# PLANNING BOARD REPORT PORTLAND, MAINE

St. Lawrence Arts Center Addition  
66-76 Congress Street  
Level III Site Plan Review  
2016-265  
Friends of the Saint Lawrence Church

Submitted to: Portland Planning Board Date: January 19, 2018 Public Hearing Date: January 23, 2018	Prepared by: Nell Donaldson, Planner CBL: 3-L001 Project #: 2016-265
--	--

Figure 3: Final site plan

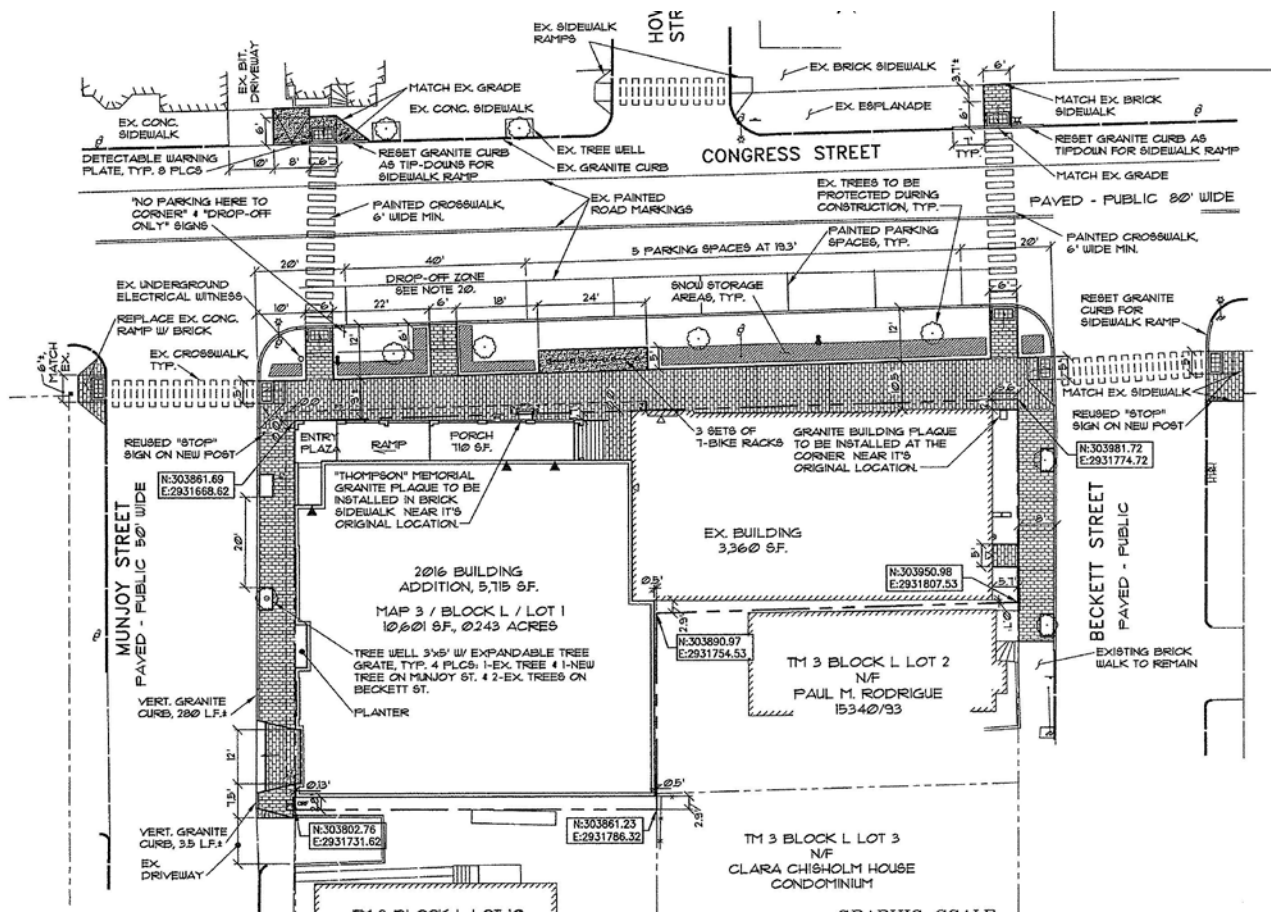
The proposed Arts Center addition will fill out the remainder of the block frontage on Congress Street between Beckett and Munjoy Streets. New brick sidewalks are proposed on the Beckett, Congress, and Munjoy Street frontages. Two ADA-accessible crosswalks are proposed across Congress Street, at both Beckett and Munjoy Streets, and improvements are proposed to the existing crosswalks across Beckett and Munjoy Streets. In his final review, Mr. Errico has requested slight modifications to proposed ramps in these locations, writing,

*The [Congress Street at Munjoy Street crosswalk] ramp flares impact pedestrian accessibility along the sidewalk. The ramp should be redesigned with dimensional details. A condition of approval should be included for final design details to be provided for review and approval prior to any City Permit.*

*Ramp flares at the westerly corner of Munjoy Street and Beckett Street currently impact the accessible route and revisions shall be provided including dimensioned*

details. A condition of approval should be included for final design details to be provided for review and approval prior to any City Permit.

4. The applicant shall provide a revised site plan including:
  - i. Details required to determine ADA compliance of sidewalk and driveway ramps with respect to grades and clearances for review and approval by the Department of Public Works;
